22 Lancaster Grove London NW3 4PB

Objection to Planning Application

Application Ref 2015/6106/P

PROPOSED FRONT ELEVATION (NORTH FACING)
1:500 A1

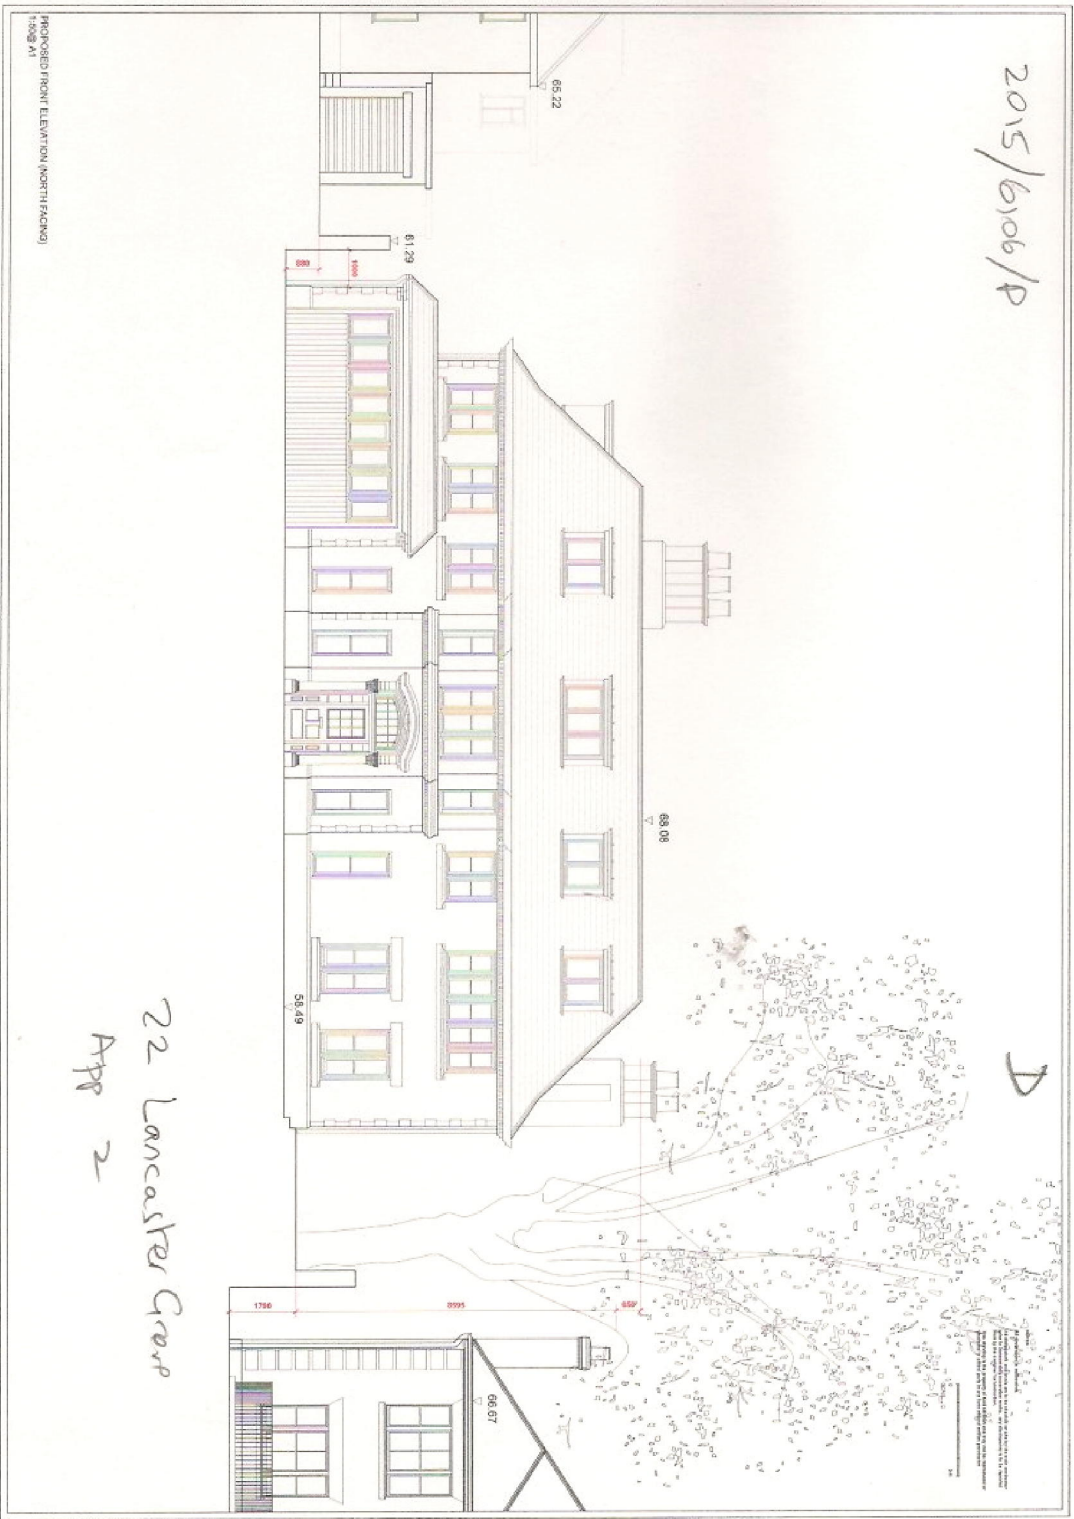
The architect has prepared an alternative elevation solution for No 22 removing the gable and this is a vast improvement. **(App 2)**

The key objections to the elevation are the Gable Ends and the Height.

- The 2 Gables facing the street will damage the view down Lancaster Grove.
 - i. The front elevation of the house is 9 metres high
 - ii. The height to the ridge of the gable is an additional 710 mm high.
 - iii. The ridge will therefore be 1.30 metres above No 18/20.
 - iv. The impact caused by the proximity of these Gables to the street, will be compounded by the height of the building.
- A building that is 1.30 metres above other buildings on the southern side will disrupt the skyline and overpower from every perspective. This height would

- Maximum developed area should be limited to 9,000 ft², as No 18/20 consent
- Reduce the height by 1.30 metres, down to the roofline of adjacent buildings.
- Remove the gable ends to reduce the impact on the street.
- Revise the elevations to match the new design for 18/20 LG.
- Reduce the depth of the house down to 10.00 metres.
- Increase the depth of the garden by 6.00 metres to circa 18.00 metres deep.
